TDECQ/TECQ/SECQ Coefficients

Brian Welch (Cisco)

TDECQ/TECQ/SECQ Reference Receiver – FFE Coefficients

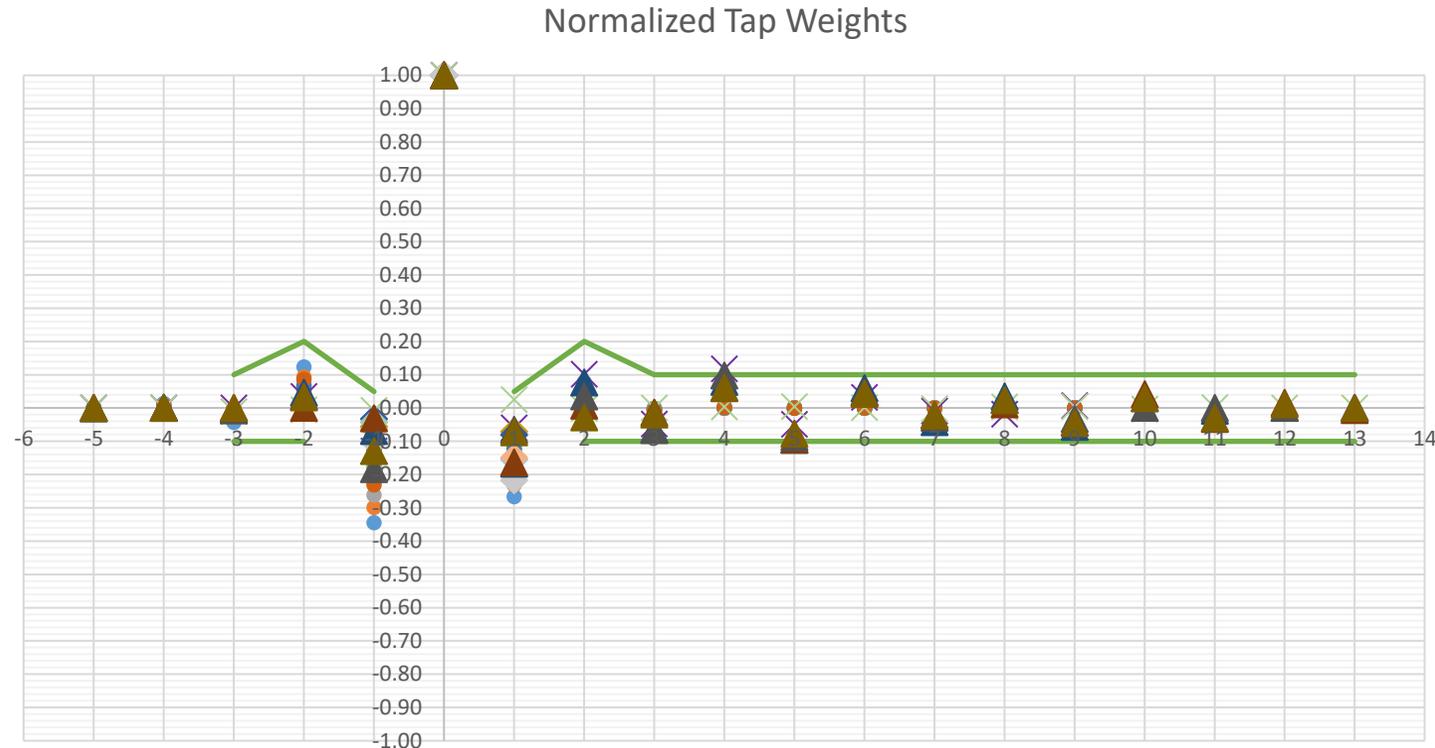
- In 802.3dj Draft 1.1 FFE coefficients were updated for 500m PMD types, except for the first pre-cursor and post-cursor min
 - Values were proposed (-0.4) but rejected
- Here new/reduced values are proposed (-0.5) and compared against an expanded data set.
- It is also proposed that these coefficient specs be applied to the 2km standards

TDECQ/TECQ/SECQ Reference Receiver – FFE Coefficients - Proposed

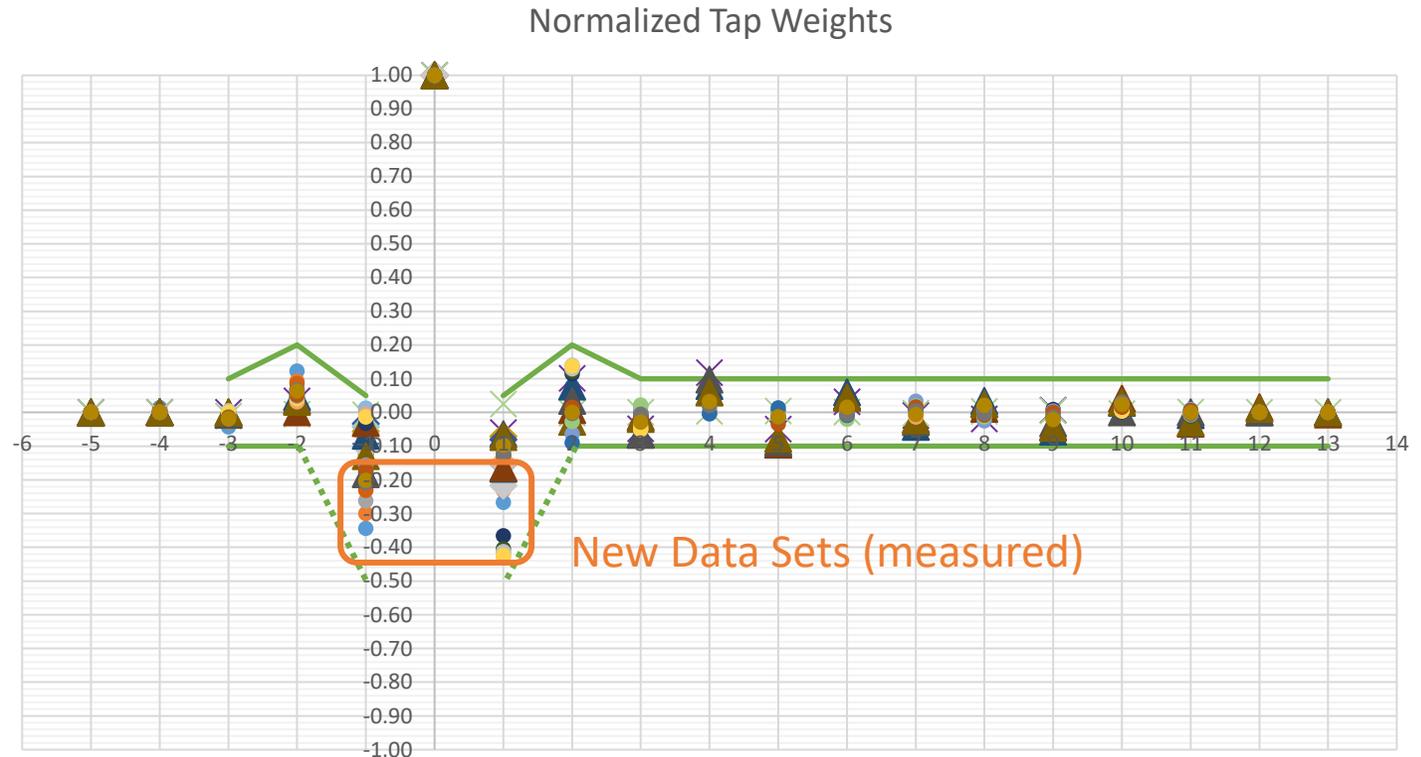
Note: Wavelength and dispersion characteristics unknown for measured results

Symbol	Min	Max	Units
Feedforward equalizer (FFE) length	N_b		15	UI
Maximum FFE pre-cursors			3	UI
Maximum FFE post-cursors			13	UI
FFE main tap coefficient limit		0.9	2.5	-
Normalized FFE coefficient limits ^a	$bb(n)$			
$n = -3$		-0.1	0.1	
$n = -2$		-0.5	0.05	
$n = -1$		-0.5	0.05	-
$n = 1$		-0.1	0.2	
$n = 2$		-0.1	0.1	
$n \geq 3$				
Equalizer Gain ^b		1	1	-
